Enclosed you will find the Technical Bulletin DOC00039 which explains the inspection and replacement of the model 3230 PC Board. It is requested that you will share this document with those who have responsibility of disseminating this information.

Your Electric Door Opener PC Board is being recalled

TECHNICAL BULLETIN DOC00039

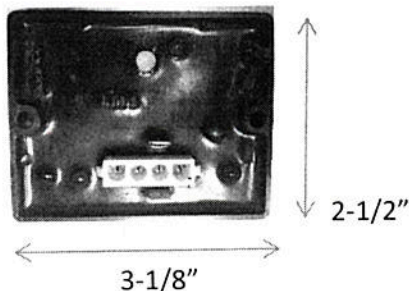
We are aware of one model of PC Board with the potential of over-heating. This PC Board (Model 3230) was supplied to and installed on certain A&M Systems Door Headers manufactured from August 1, 2009 through March 31, 2010. Additionally, PC Boards that were field replaced during this time period could be affected and will need to be inspected. While these reports are few, the over-heating situation could cause the PC Board to burn in extreme cases. As a result we are sending this Technical Service Bulletin to help you identify and replace this PC Board.

Only the Model 3230 PC Board has shown the potential to over-heat. Please be aware of the importance of this Technical Bulletin. Your prompt attention to this is highly recommended and should be completed no later than December 31, 2013.
